Ref: 9361

February 17, 2023

Re: Response to Independent Peer Review for Emerson Homes  
Proposed Age-Qualified Multifamily Residential Development – 10 High Street (Route 97)  
Topsfield, Massachusetts

PROJECT: PROPOSED AGE-QUALIFIED  
RESIDENTIAL DEVELOPMENT  
TOPSFIELD, MASSACHUSETTS

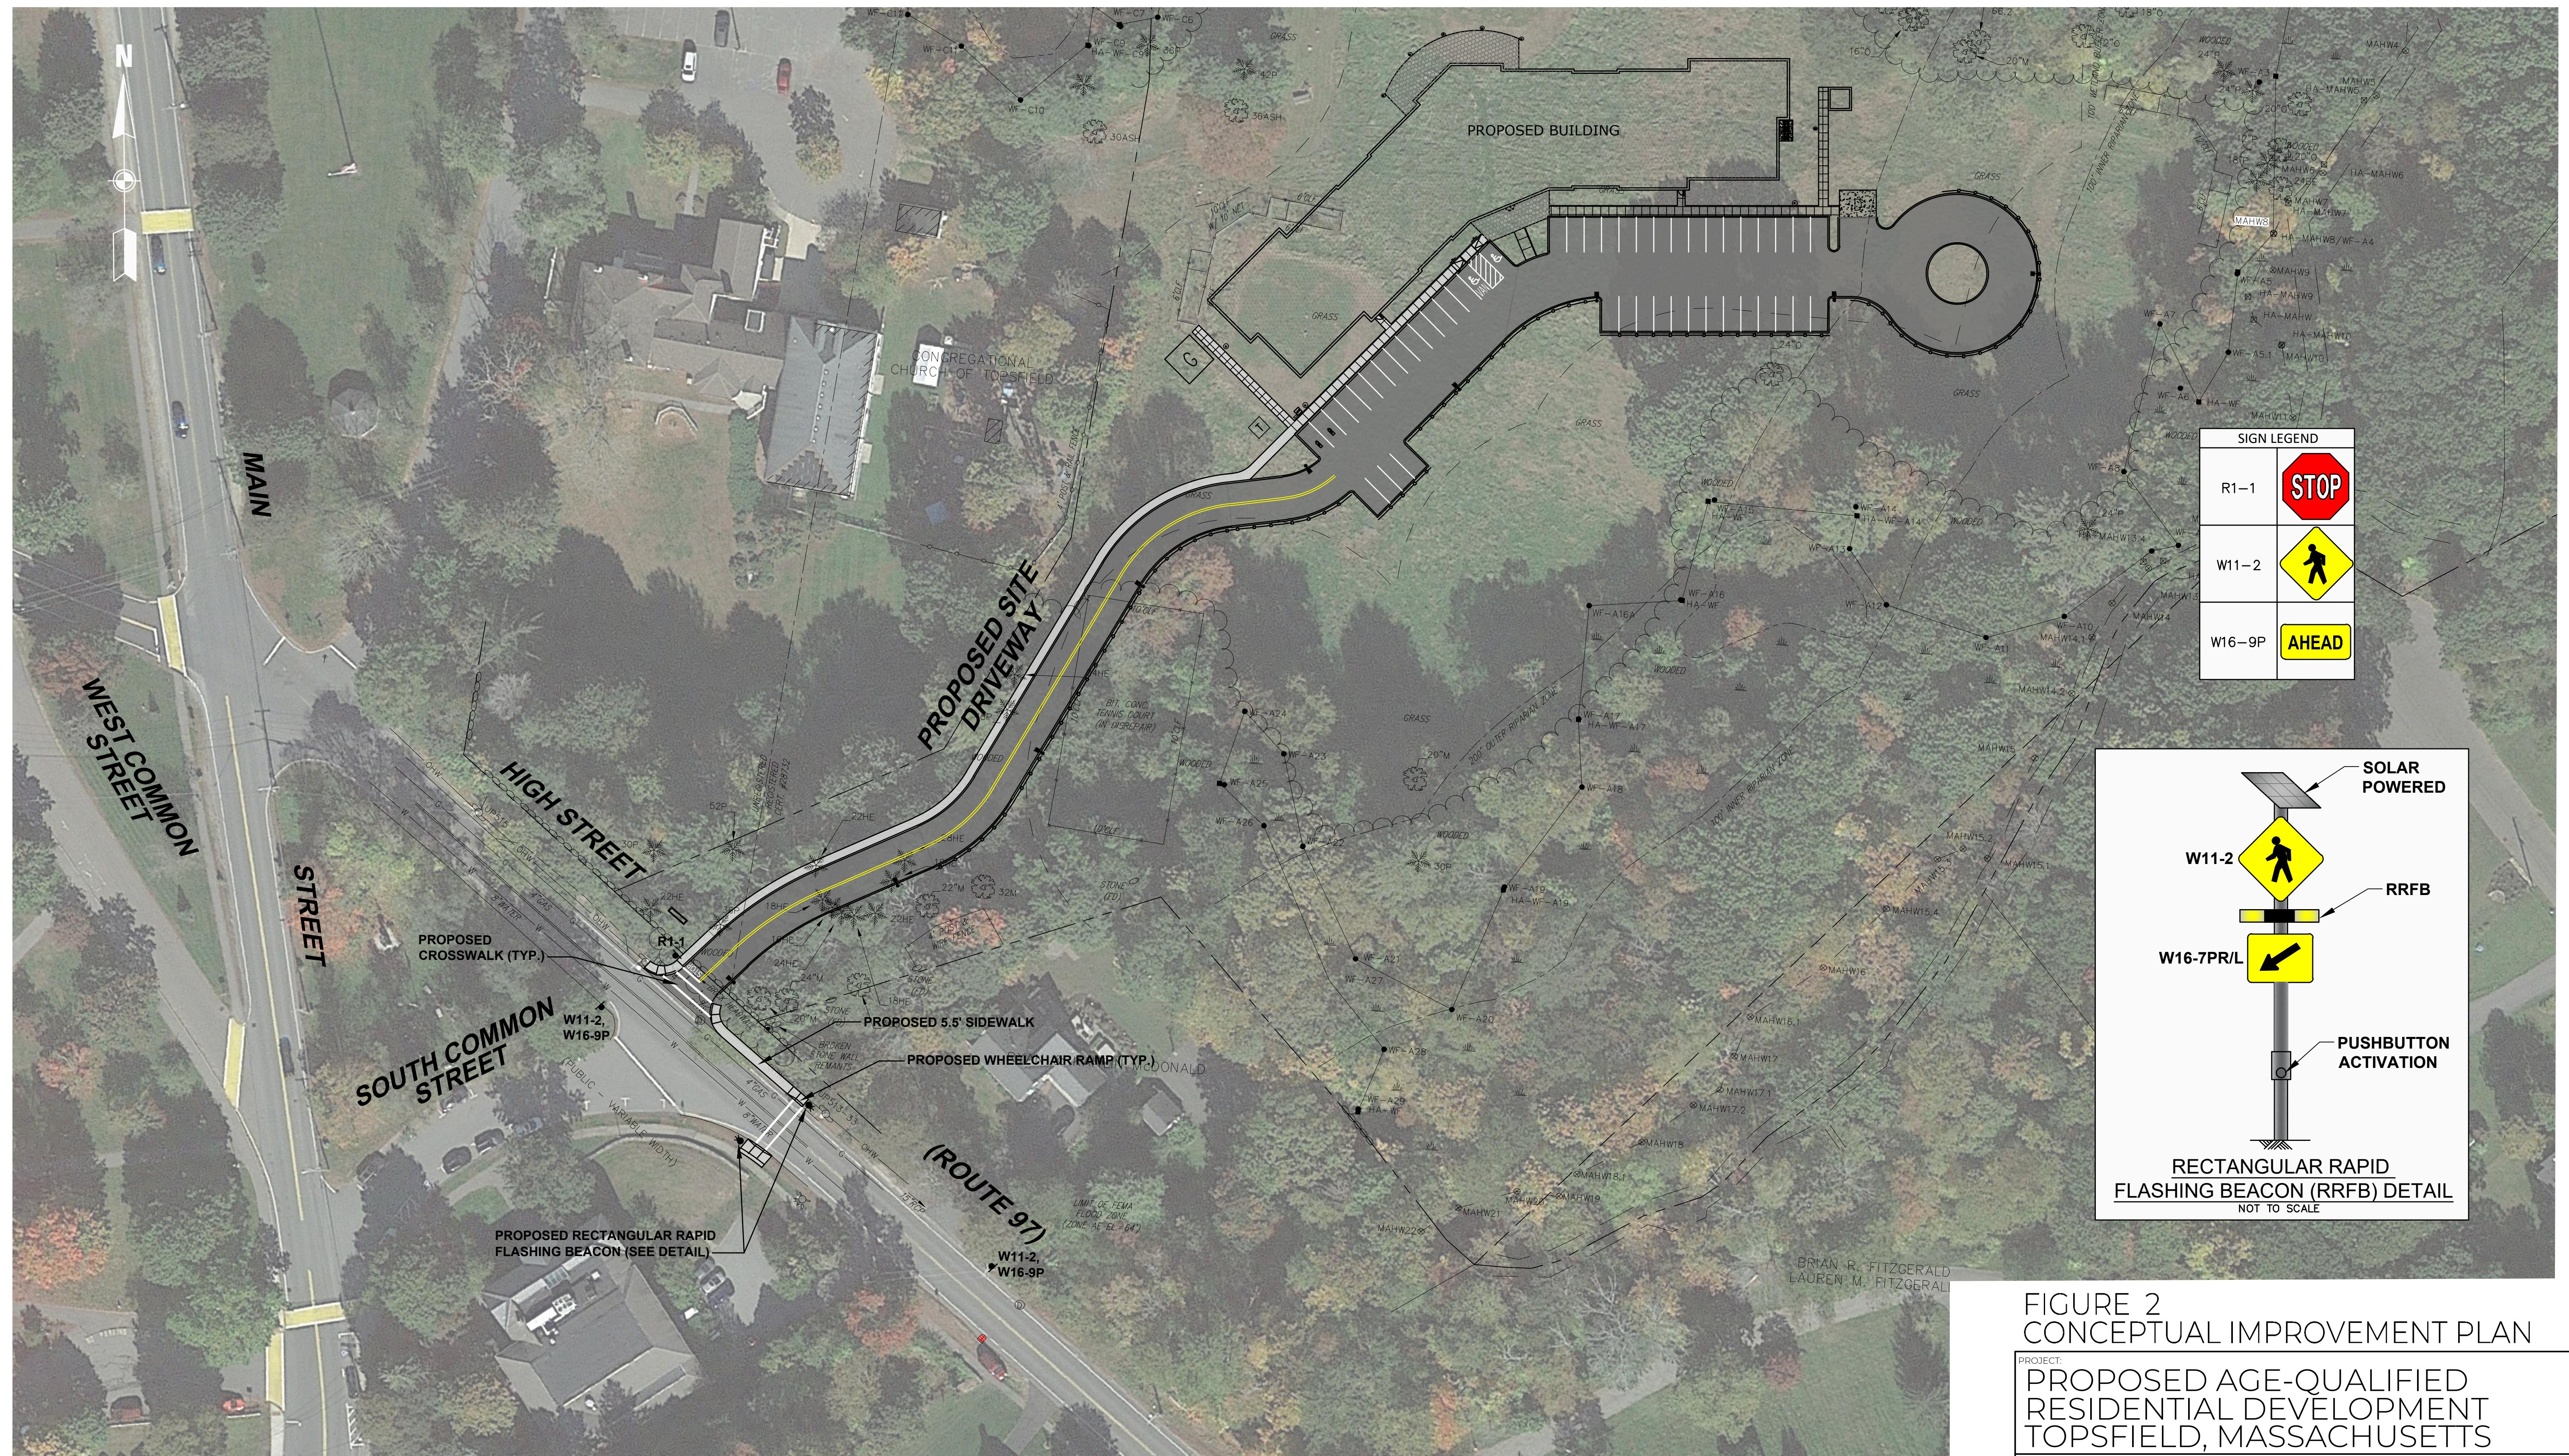
**Comment 19:** *Relative to the request from Chappell Engineering Associates for defined sight line triangles, with only 100-ft of frontage, we request that the Applicant document if easements will be required from abutting properties to keep the sight triangles maintained and clear of vegetation.*

**Comment 14:** *It is recommended that a sight line plan be developed to specifically identify the areas of vegetation removal necessary to ensure that adequate sight distance will exist. It is further recommended that the sight triangle areas be kept clear of any obstructions such as landscaping, signs, or fences and be regularly maintained to assure adequate sight distance.*

**Response:** As can be seen on Figure 1, the sight triangle areas are contained within the Project site or the public right-of-way. As such, sight line easements are not required for the Project.

**Response:** Figure 1 depicts the sight triangle areas for the Route 97/Project Site driveway intersection and includes a note stating: "Signs, landscaping and other features located within sight triangle areas shall be designed, installed and maintained so as not to exceed 2.5-feet in height. Snow windrows located within sight triangle areas that exceed 3.5-feet in height or that would otherwise inhibit sight lines shall be promptly removed." The Applicant will accept a condition requiring that the sight triangle area be kept clear of obstructions pursuant to the note on Figure 1.
